INNER WEST COUNCIL

DEVELOPMENT ASSESSMENT REPORT

Application No.	D/2018/490
Address	168 Norton Street, LEICHHARDT NSW 2040
Proposal	Demolition of all structures on site. Site remediation, construction of a 5 storey building to provide residential accommodation for seniors and associated community use at ground level, plus a new retail shop fronting Norton Street at ground floor level with two levels of basement car parking are proposed providing parking for 57 vehicles at 168 Norton Street, Leichhardt.
Date of Lodgement	13 September 2018
Applicant	Uniting
Owner	The Uniting Church In Australia Property Trust NSW
Number of Submissions	21
Value of works	\$16,920,000
Reason for determination at Planning Panel	Planning Agreement / SEPP 65 (4 Storeys or higher) / Number of submissions / subject to a Voluntary Planning Agreement
Main Issues	Vehicular access Waste management Heritage impacts Visual and acoustic privacy
Recommendation	Deferred Commencement Approval

Figure 1: non-compliance with built form control on the eastern elevation. (shown in white exceeding the blue building envelope)

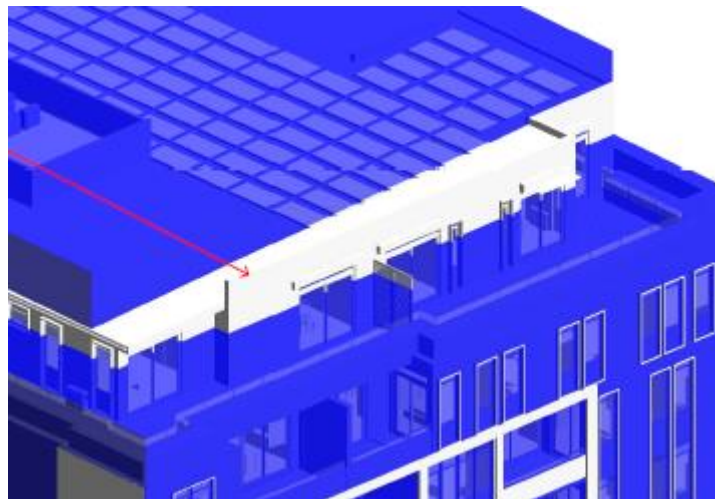
The proposal includes a non-compliance with G9.6.1 C1 and C2 in that the setback of the fifth storey is less than 6m with a setback of 3.8m.

Figure 2: Non-compliance with built form control on the northern elevation. (shown in white exceeding the blue building envelope)

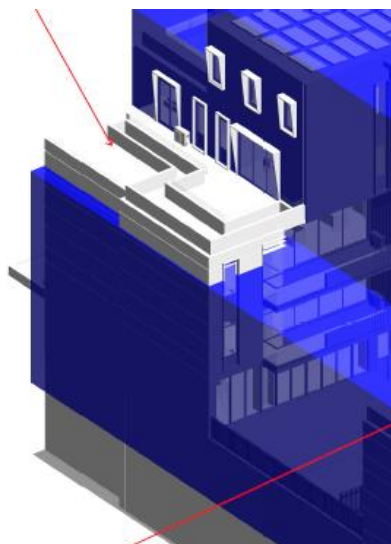
The proposal includes a non-compliance with G9.6.1 C1 and C5 in that the height on the northern boundary in part RL 41.9 whereas the control requires RL 40.40. This non-compliance is limited to the section of the development as indicated in the below image.

Figure 3: Non-compliance with built form control on the stairwell. (shown in white exceeding the blue building envelope)

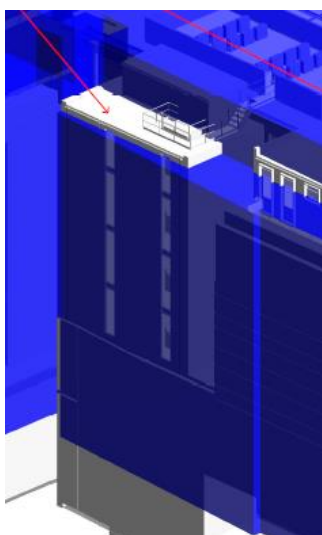
The proposal also includes a small non-compliance with G9.6.1 C1 related to the height of the stairwell. This non-compliance is obscured behind the adjoining shops to the south east of the site. This non-compliance is indicated in the below image.

Figure 4: Non-compliance with rear lane setback. (shown in white exceeding the blue building envelope)

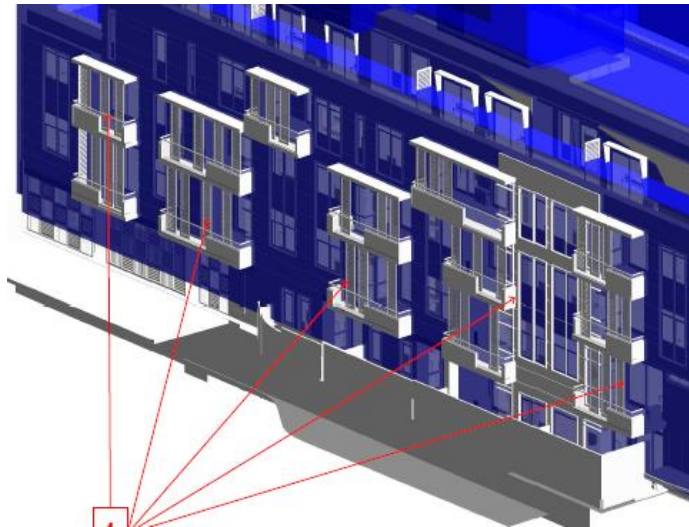
The proposed development is largely consistent with the setback controls contained within G 9.6.2, however, the following non-compliances exist in relation to the setback of the fifth floor setback from Norton Street (C6) and the 3rd floor not being setback 6m from the northern boundary (C13). The balconies off the rear lane are within the 3m setback and part of apartments encroach on the rear lane setback for 0.3m as shown below:

Figure 5: Non-compliance with rear lane setback. (shown in white exceeding the blue building envelope)

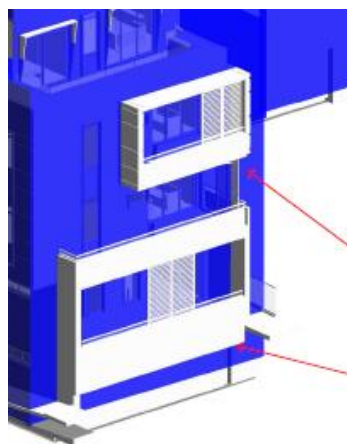
The proposal also has non-compliances in relation to the Carlisle Street setback (C8).as shown below:

Figure 6: Screening of the communal terrace on the northern side.

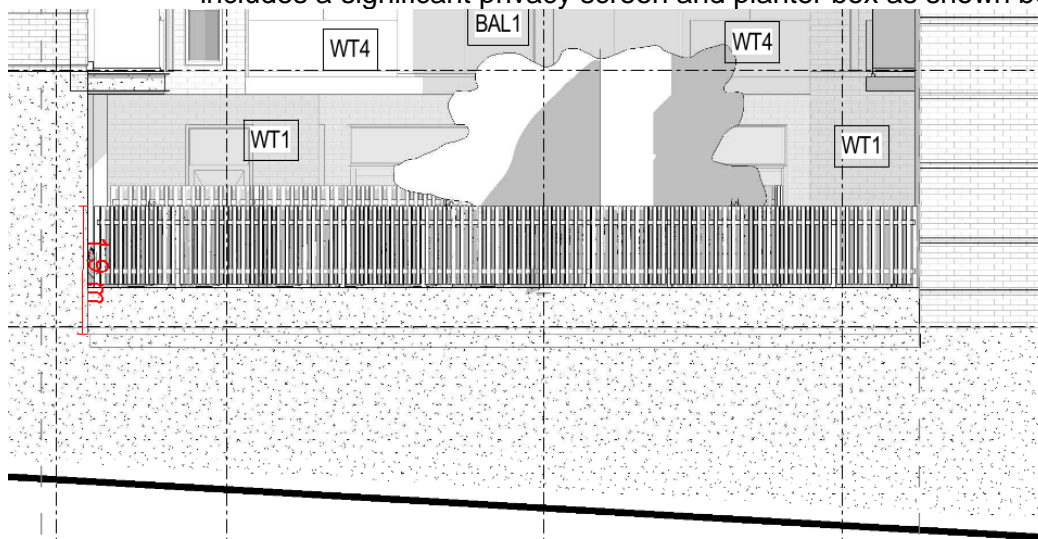
Issue: Visual privacy to 2, 4, 6 and 8 Macaulay Street.

Comment: As addressed within C3.11 subject to the recommended conditions of consent the proposal is considered to have acceptable impacts on visual privacy noting that separation via distance as referred to within *Meriton v Sydney City Council* [2004] NSWLEC 313. With reference to the courtyard the proposal includes a significant privacy screen and planter box as shown below:

Figure 7: Privacy issue with balcony of apartment R4-06.

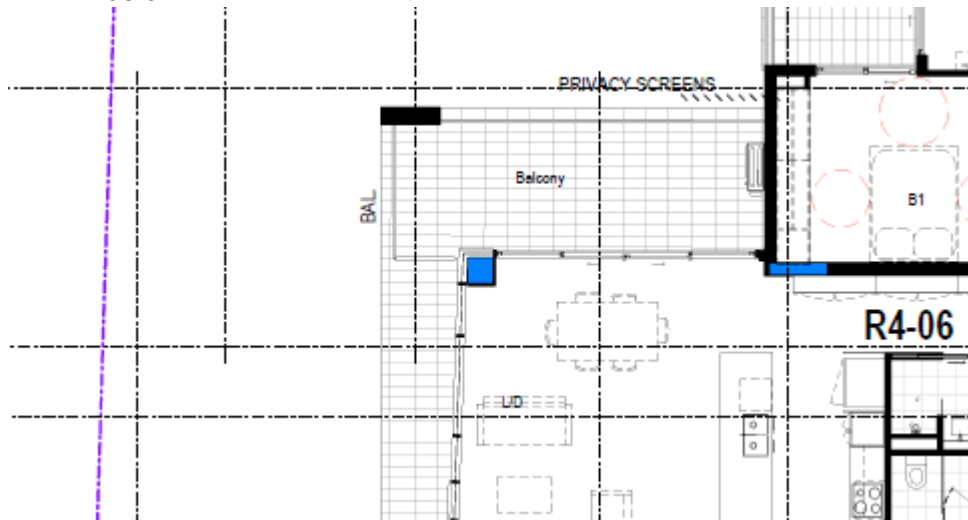
With regard to the balconies on the northern side on the development, separation has been achieved via distance, planter boxes and setback balustrades for all balconies with the exception of the level 4 balcony off apartment R4-06. As shown below:

A condition of consent is recommended setting back the balustrade on the northern side to be in line with the edged of the living room. This will provide a horizontal privacy screen to the adjoining properties. It is noted that the apartment above this on level 5 maintains a setback that is acceptable.
